Service Bulletin

SEB95-19

LOWER FORWARD DOORPOST AND STRUT FITTING INSPECTION AND MODIFICATION

Figure 2. Lower Forward Doorpost Bulkhead and Wing Strut Fitting Reinforcement (Sheet 3)

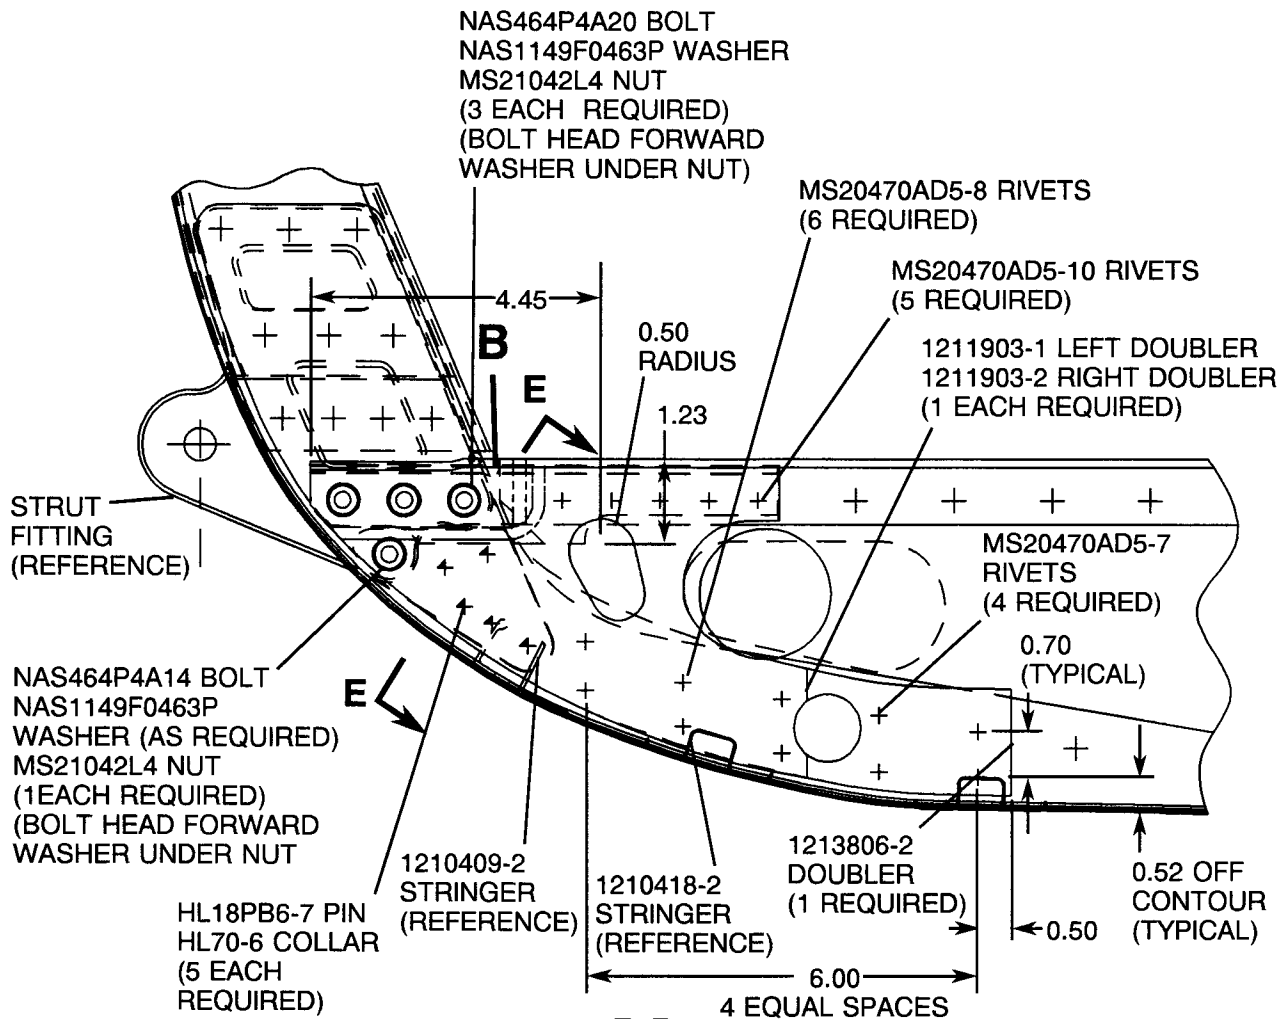
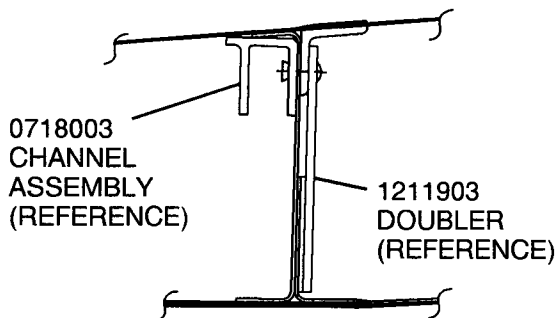
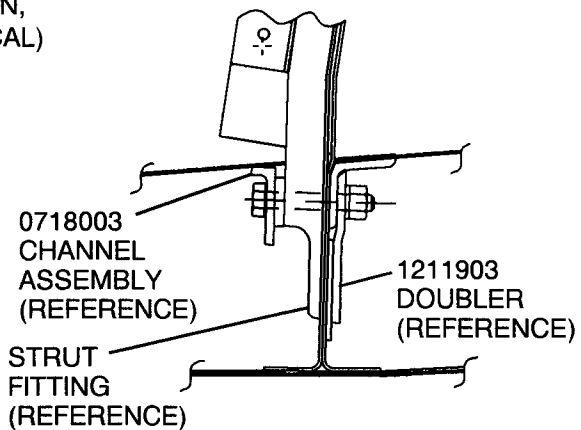
- D. Remove the hardware securing the 1211903 and 1213806 doublers. Deburr all holes in the doublers, channel assemblies and structure. Install all rivets and fasteners to retain the channel assemblies and doublers. (Refer to Figure 2, Sheet 3, View B-B.)

Figure 2. Lower Forward Doorpost Bulkhead and Wing Strut Fitting Reinforcement (Sheet 4)

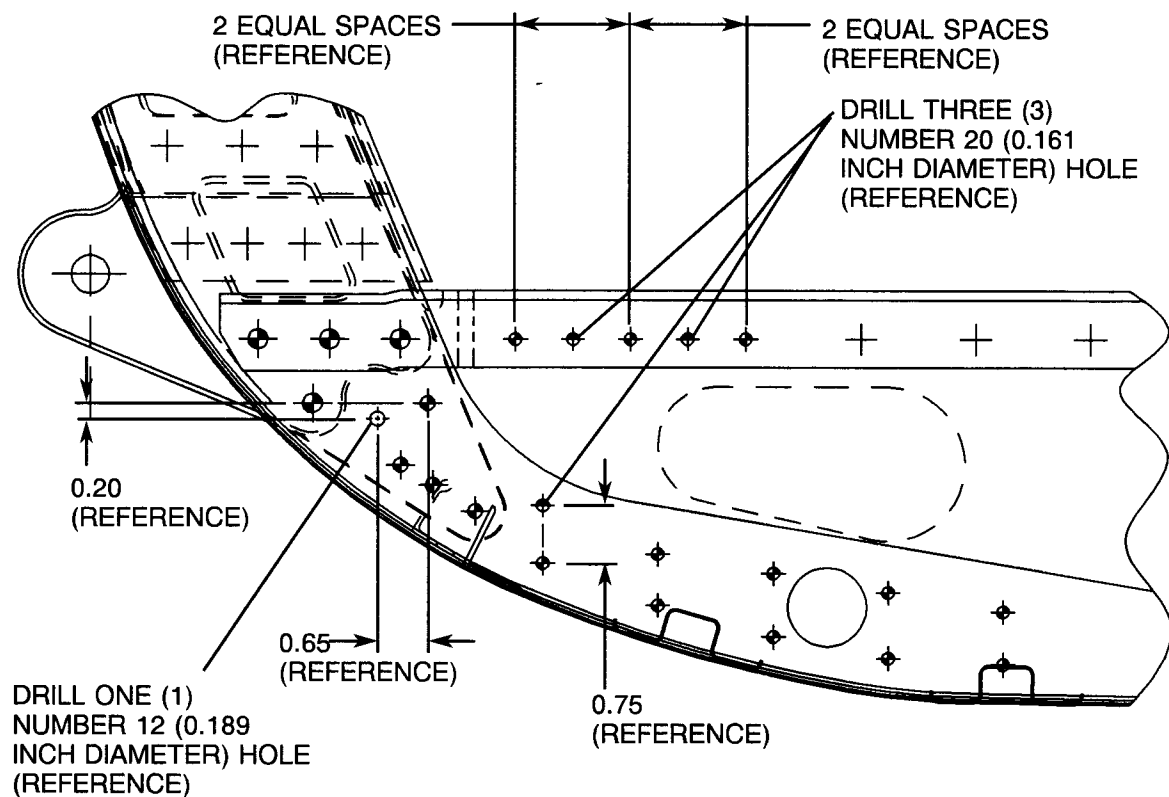
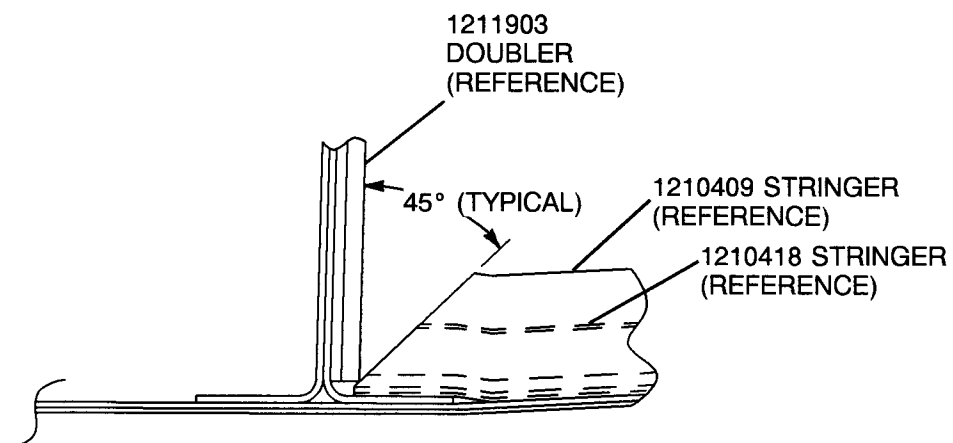
15. Drill one (1) Number 12 (0.189 inch diameter) hole. (Refer to Figure 2, Sheet 4, Detail B.)
16. Drill three (3) Number 20 (0.161 inch diameter) hole. (Refer to Figure 2, Sheet 4, Detail B.)

- C. Install the 1211903-1 and -2 doublers with the NAS464P4A14 bolts, NAS1149F0463P washers and MS21042L4 nuts in location. Drill holes in the 1211903 and 1213806 doublers to match the structures. (Refer to Figure 2, Sheet 4, Detail B.)
